**CITY OF ISANTI
PLANNING COMMISSION MEETING
TUESDAY, February 15, 2022
Immediately Following the 7:00pm City Council Meeting
CITY HALL**

MEMORANDUM

SUBJECT: Site Plan Review and CUP Approval for a Commercial building for Little North Boutique with a drive-thru located at 291 5th Ave NE

Date: February 7, 2022
To: Stephanie Hillesheim, Community Development Director
From: Jason W Cook, P.E.
City Engineer
Subject: Little North Boutique - Plan Set - Engineering Review
City of Isanti, MN
Project No.: 0R1.123130

Site Plan C-4:

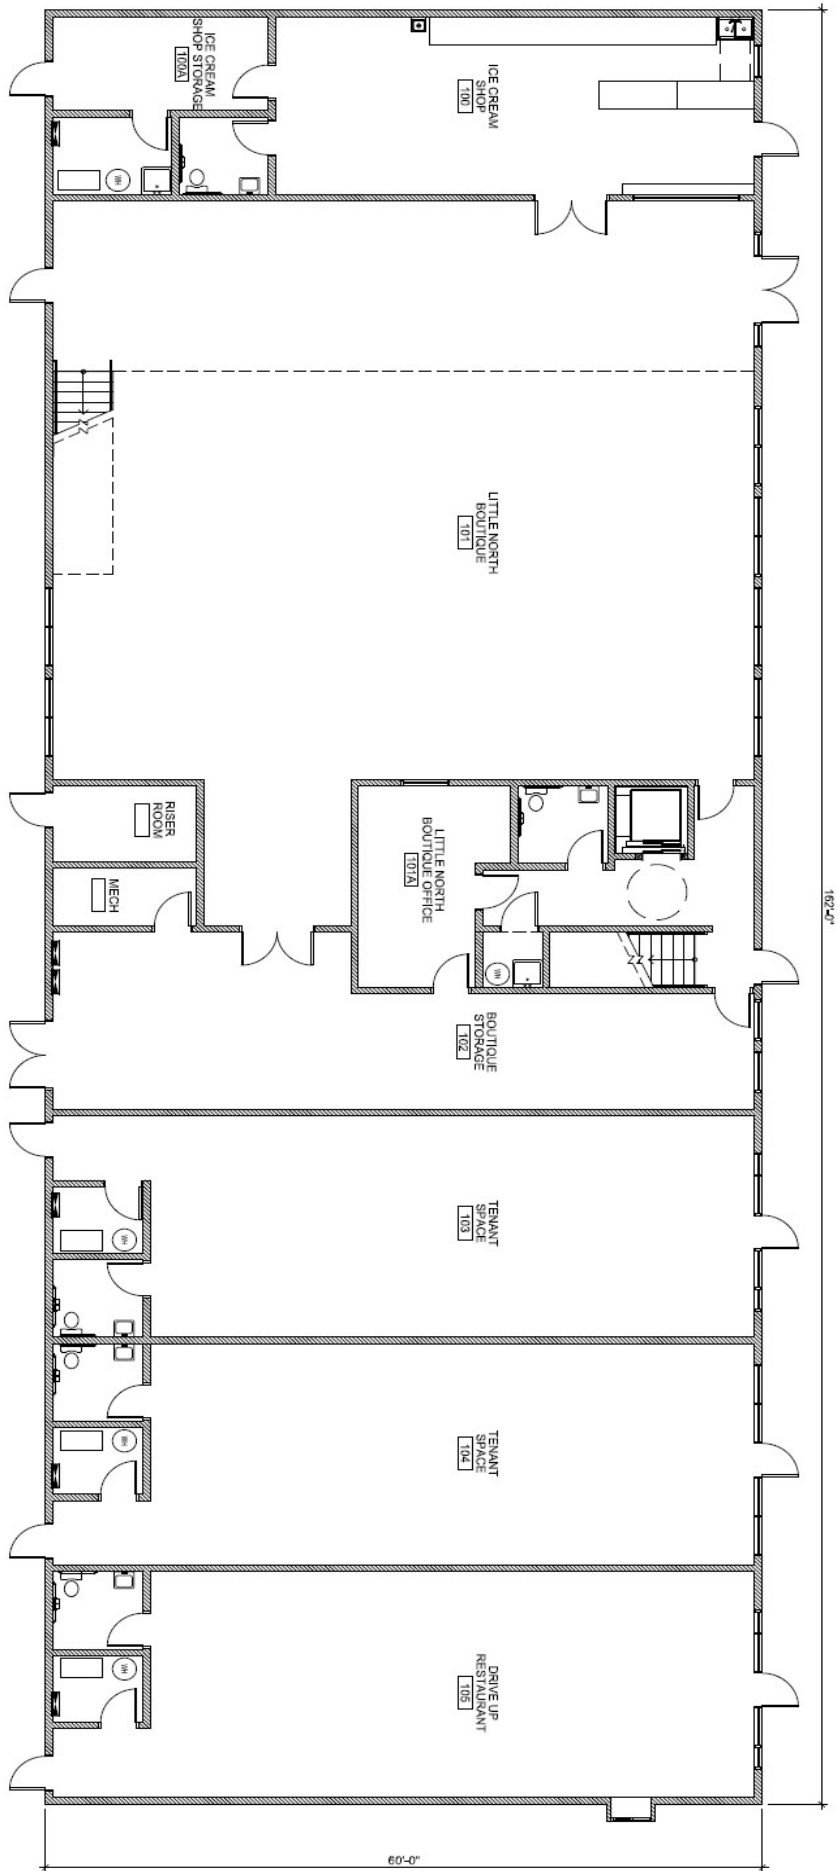
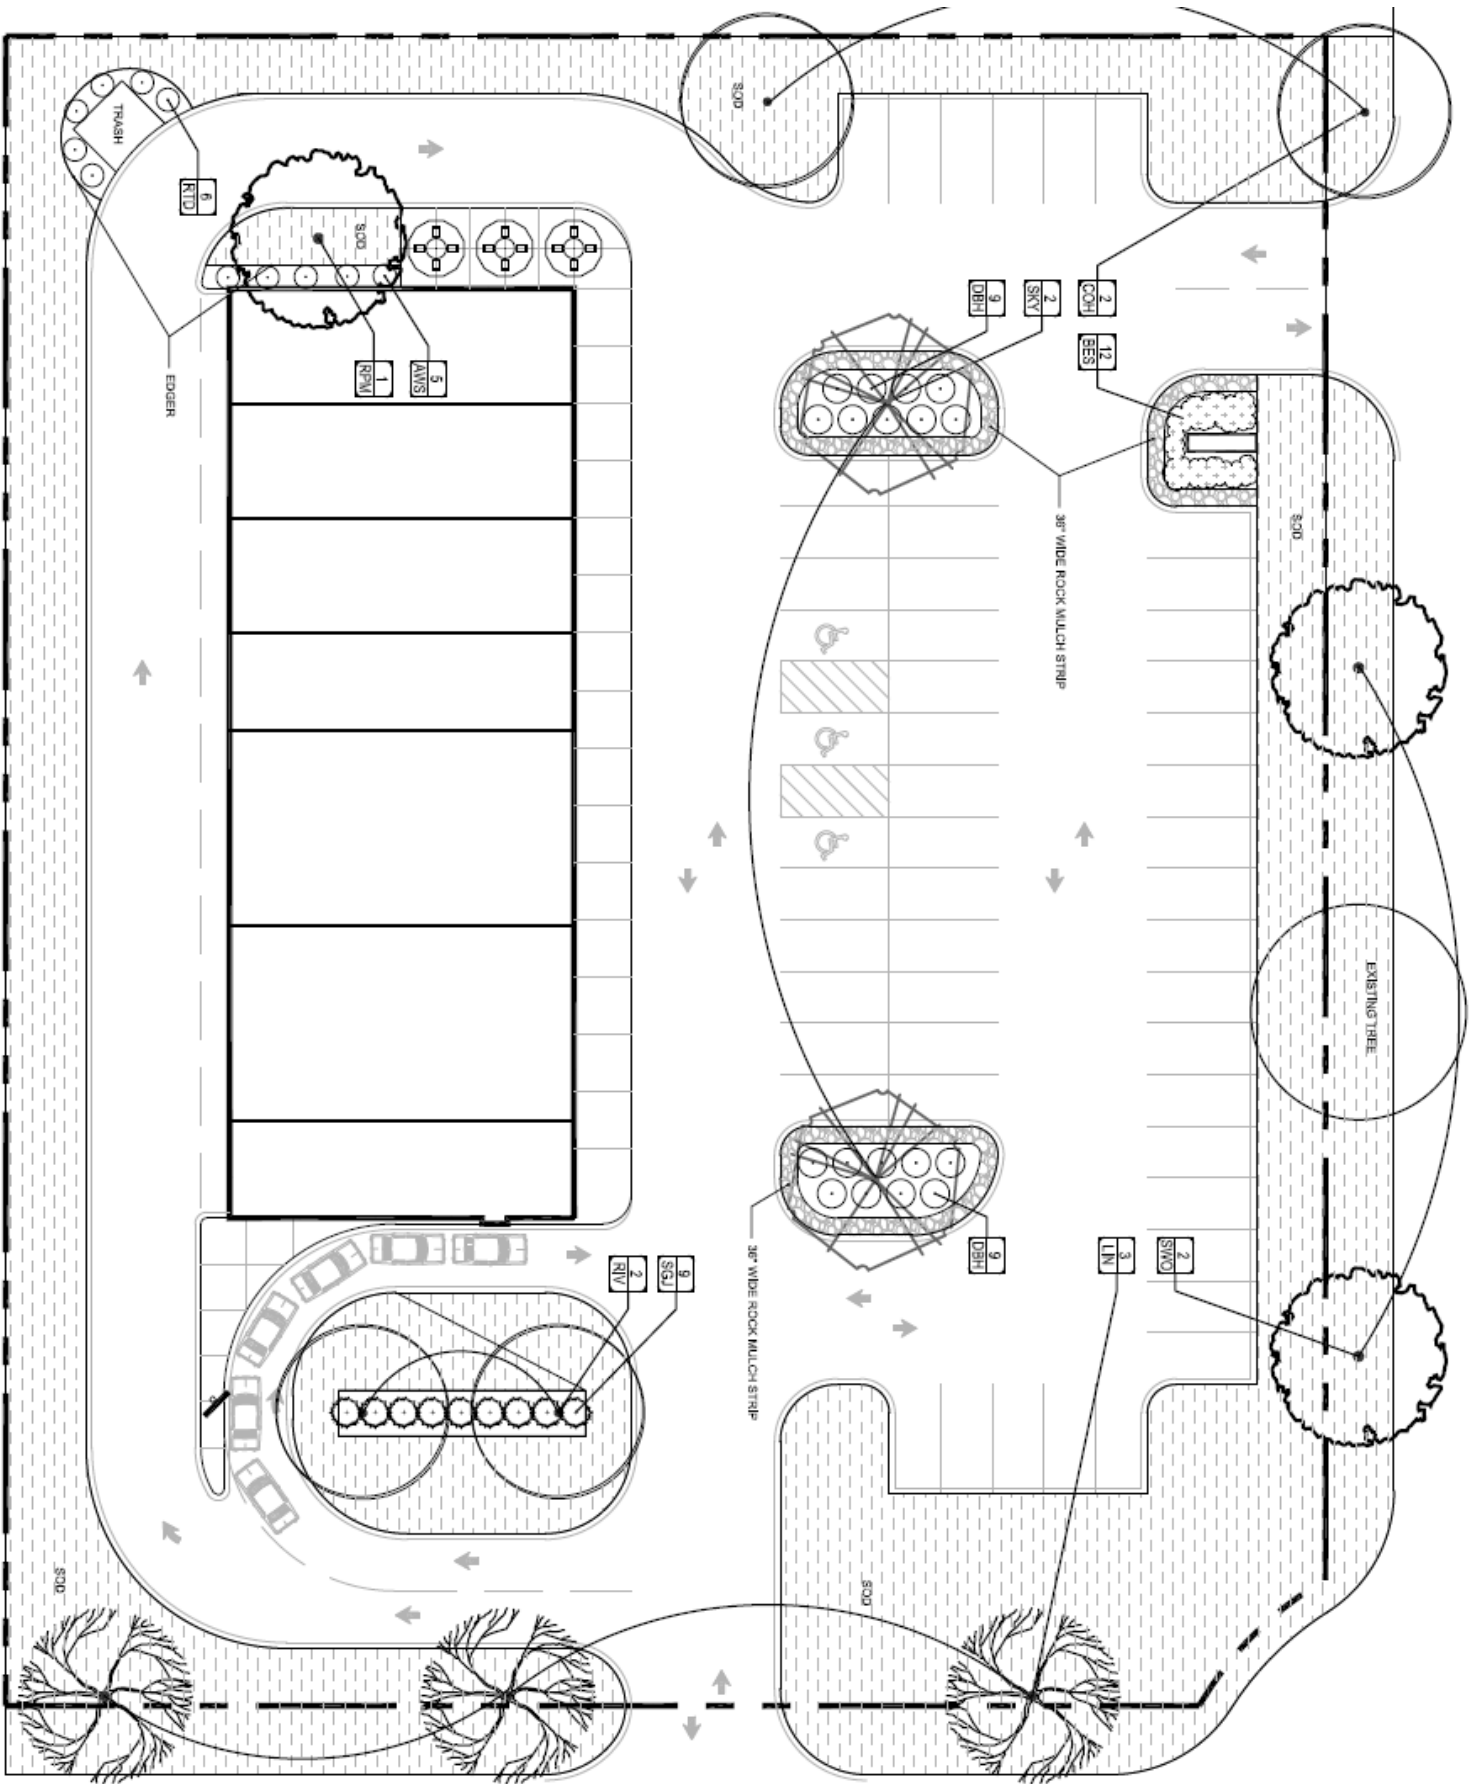
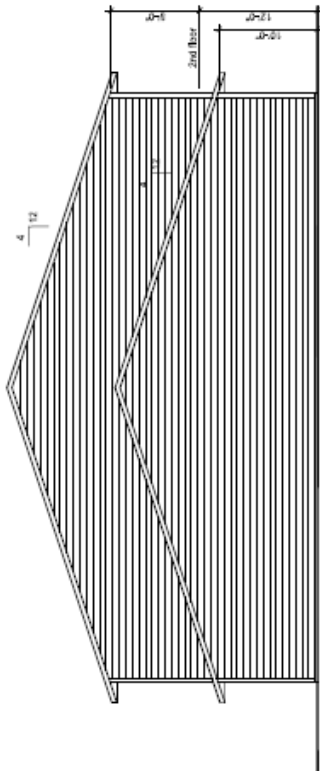
A by-pass lane is not provided that runs parallel to the drive thru lane, allowing vehicles to exit the drive-thru lane from the stacking lane. The curbing shows a 12 ft width of the drive-thru lane which will need to be extended to provide a by-pass lane.

2. A concrete valley gutter will be needed at each proposed entrance. See attached detail.
3. Depict where gutter out curb will be used.
4. A bypass lane is required on the drive through.
5. Post signage and striping to designate One-Way road or widen loop to 24-ft F-F and modify drive through area on east end.
6. Submit retaining wall detail.

4 EAST ELEVATION
A2 1/8" = 1'-0"

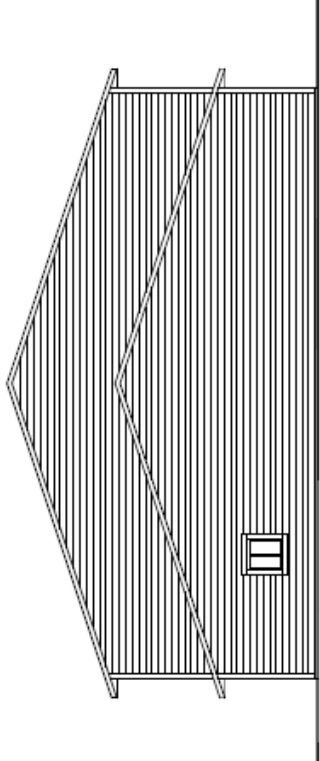
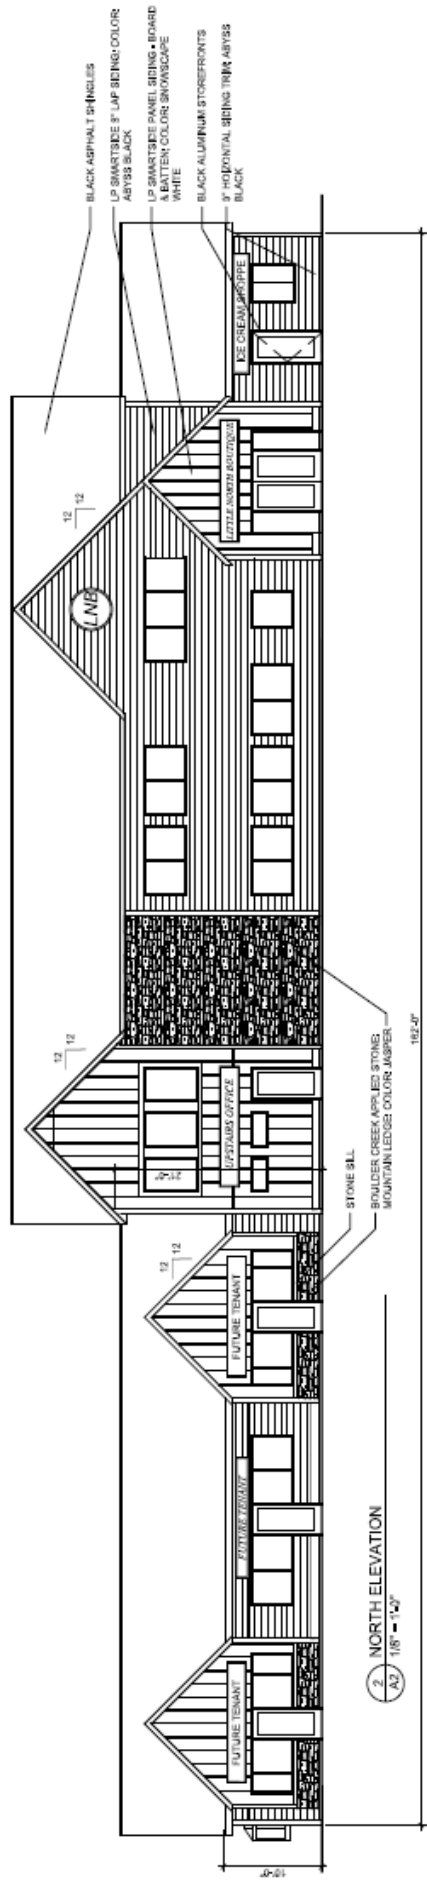
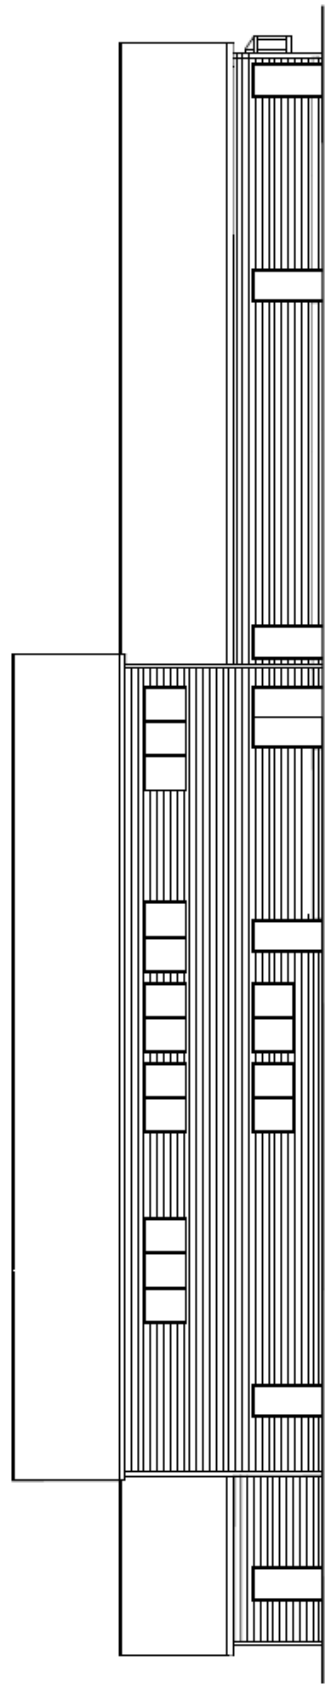
The proposed drive-thru window will be located on the east side of the building and will not be directly adjacent to a public street.

The exterior building elevations display one drive-thru window and one designated queuing lane.
